HVA Tuesday 8 February 2022

Junction safety at Howards Lane/London Road

The Consultation Plan as displayed

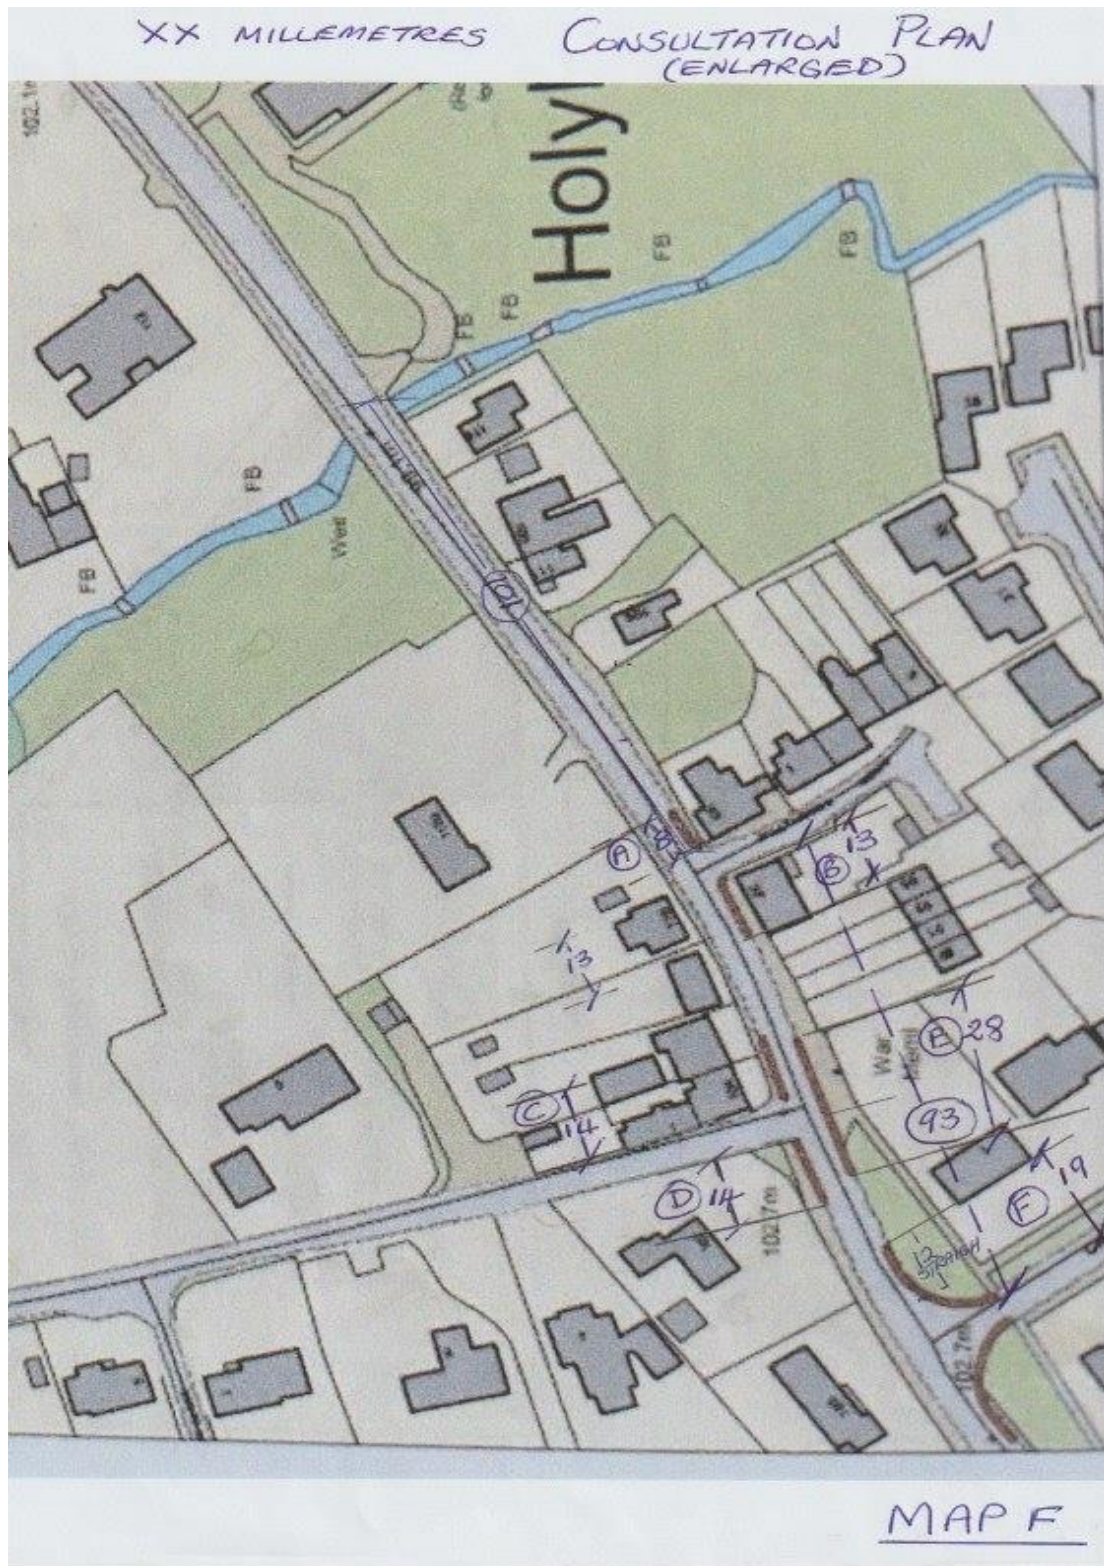
- C goes one third along the frontage
